RE: Modification to Approved Vesting Tentative Subdivision Map 06-02 (Schill)  
Located South of Nord Highway and West of Esplande; APN 006-840-006

S 06-02 Schill Subdivision - Modification (Webb)  
 APN: 006-840-006-000

**SCHILL SUBDIVISION (506-02)**  
VESTING TENTATIVE MAP  
A PUBLIC STREET SUBDIVISION

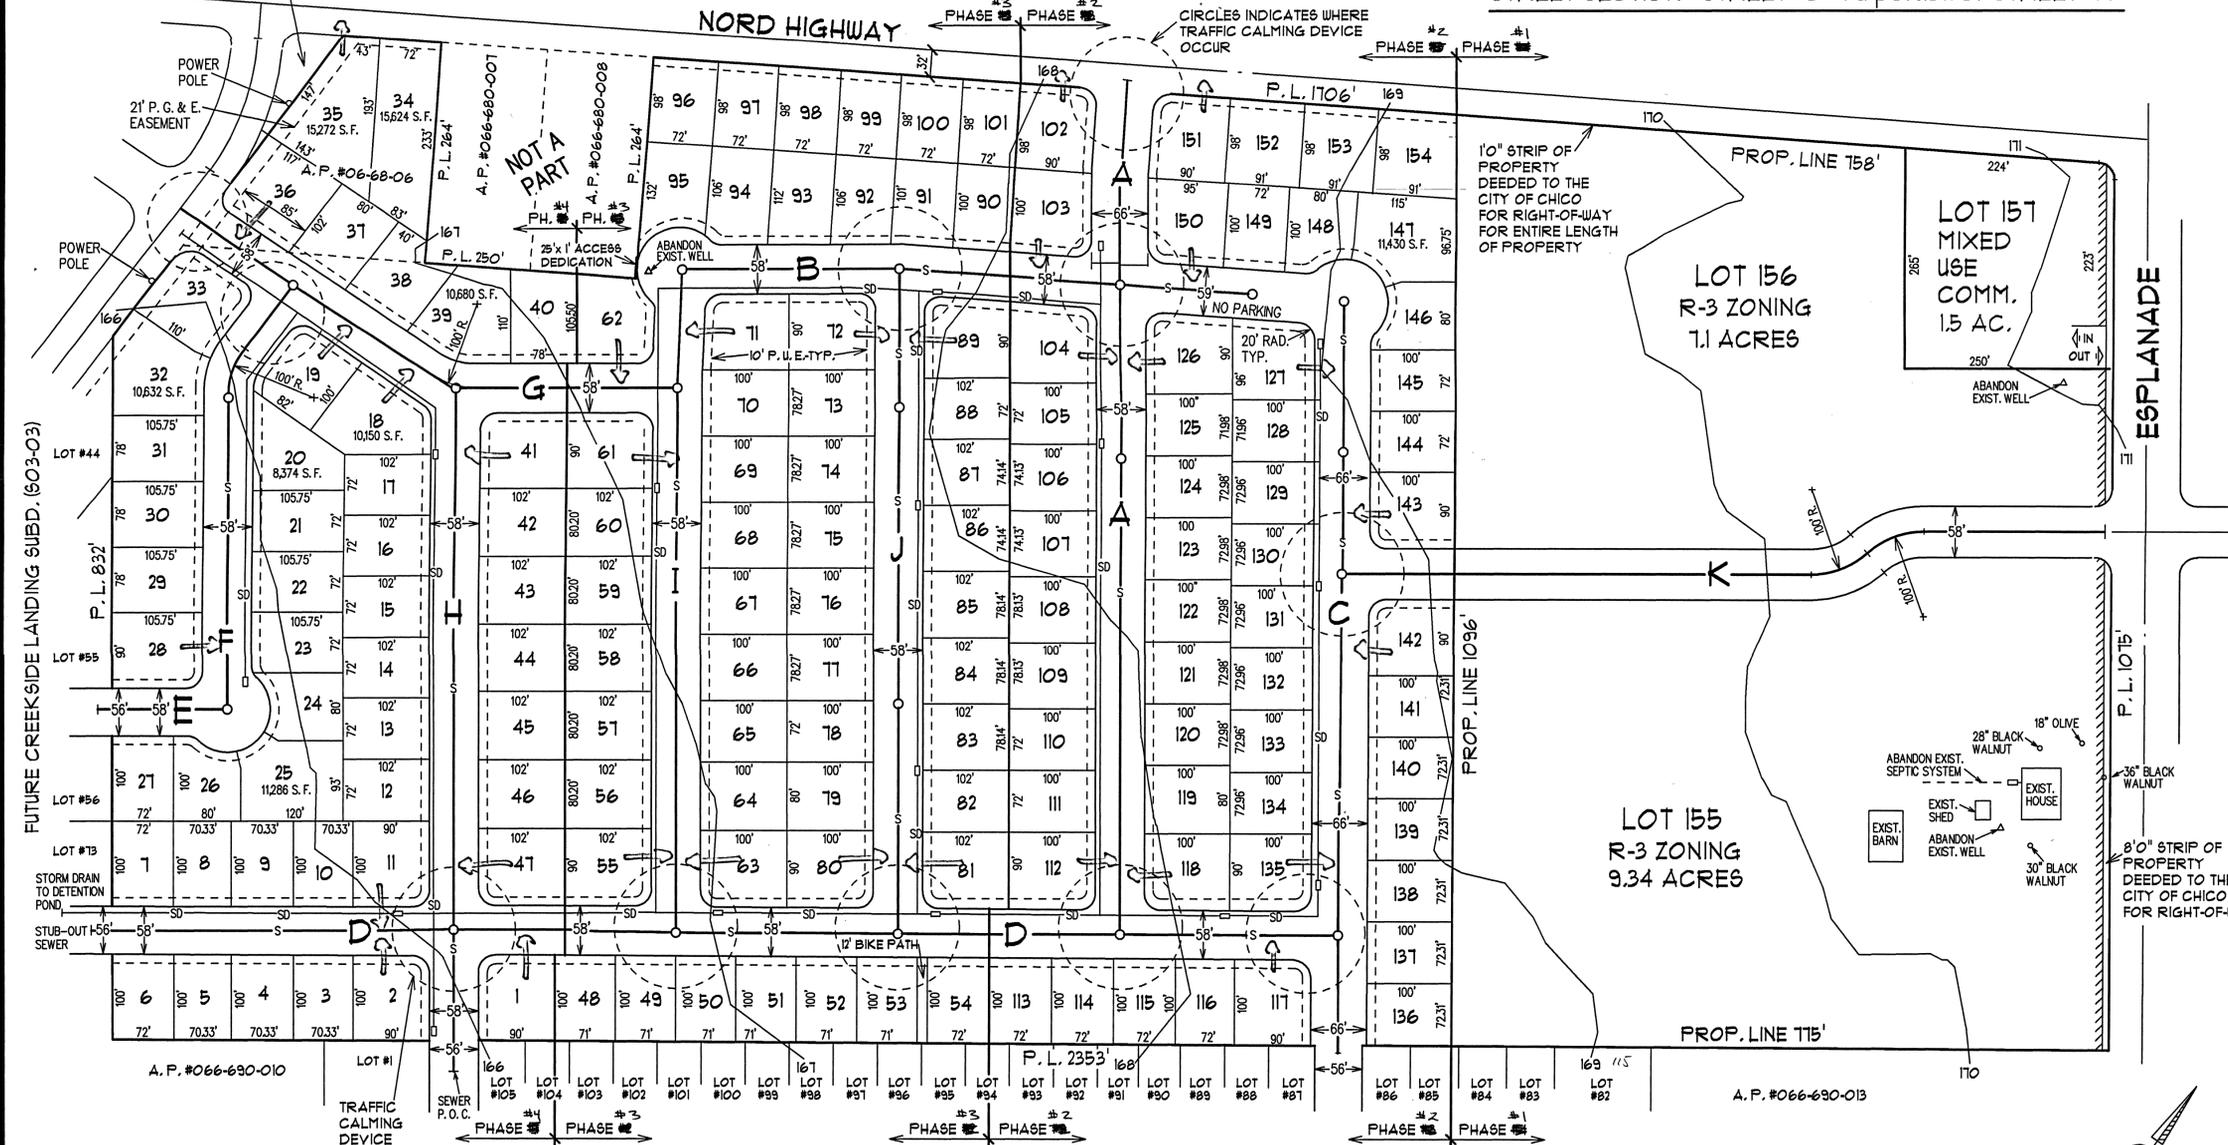
The applicant proposes to modify approved Vesting Tentative Subdivision Map S 06-02. The proposal would eliminate a 12 foot wide bicycle/pedestrian path from between lots 53 and 54 of the approved vesting tentative map. No significant concerns have been identified.

The proposed modification would include the elimination of a 12 foot wide bike path between lots 53 and 54 that would connect Street D (Antelope Creek) of the approved Schill subdivision (S 06-02) with Bentwater Loop to the south after passing between lots 93 and 94 of the approved Montecito subdivision (S 06-05) (see **Attachment C**). Prior to the current approved street layout for the subdivision, the Northwest Chico Specific Plan included development of

18. ~~The project improvement drawings shall illustrate a 12-foot wide bicycle/pedestrian path (eight feet of paving with landscaping on each side) extending to the south from the south side of Street "D" and constructed between Lots 53 and 54.~~
19. Provide a deed notice for the sale of resulting Lots 136 through 147 and Lot 154 notifying purchasers of the location of the R3 Medium-High Residential zoning district adjacent to the east of said lots.

Planning staff recommends adoption of Resolution No. 16-20 (**Attachment A**), approving modification to approved vesting tentative subdivision map S 06-02, subject to the attached conditions.

FIGURE 5-15

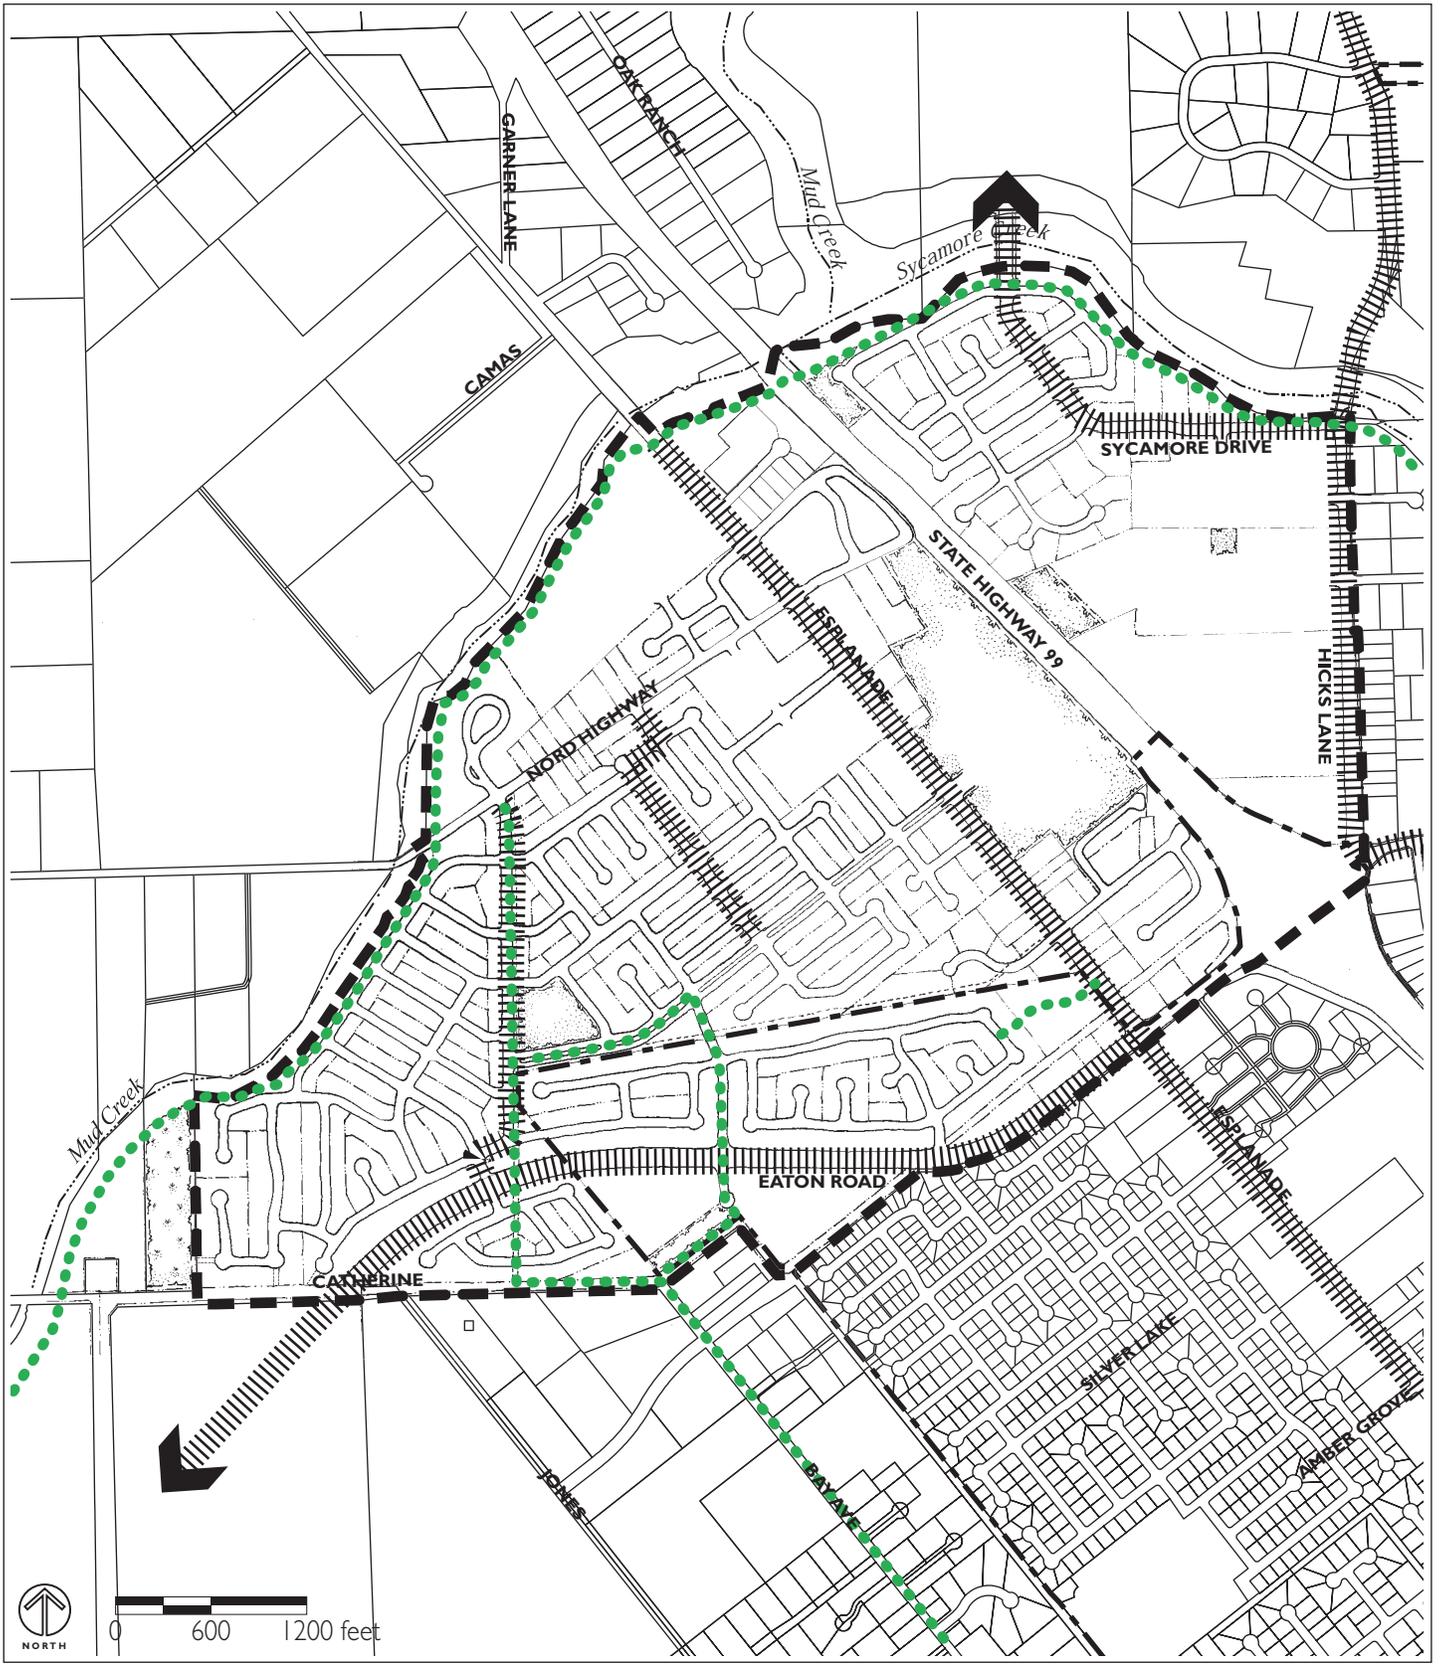
the site as incorporating multiple cul-de-sacs in the planned circulation network (see **Attachment D**). The incorporation of the cul-de-sacs in the circulation network would have resulted in the need for increased bicycle and pedestrian paths to allow the Specific Plan to conform to the General Plan Goals for Circulation (CIRC-1.2, CIRC-2.1, CIRC-3, and CIRC-4) and Community Design (CD-2.1, CD-3.2). A redesign of the approved subdivision eliminated cul-de-sacs from the street network and therefore increased pedestrian and bicycle connectivity throughout the project site. The redesigned street layout allows the proposed project area to be consistent with the goals of the Northwest Chico Specific Plan to develop and multi-modal circulation pattern that facilitates connectivity from residential neighborhoods to both the Esplanade and the area's open space amenities as well as previously listed General Plan goals for Circulation and Community Design.

The Planning Commission's decision to modify the conditions of approval creating this path is without merit. When the Northwest Chico Specific Plan (NWCSF) was being considered it depicted Schill subdivision with multiple cul-de-sacs(Fig. 5-15). Concurrent with the adoption of the NWCSF and proposed Schill subdivision, modifications to the street layout replaced the cul-de-sacs with through roads. This results in a greater connectivity for both vehicle and pedestrian traffic. Furthermore, these short inter-connected bike paths adjacent to homes have proven to be both a maintenance problem and public safety issue.
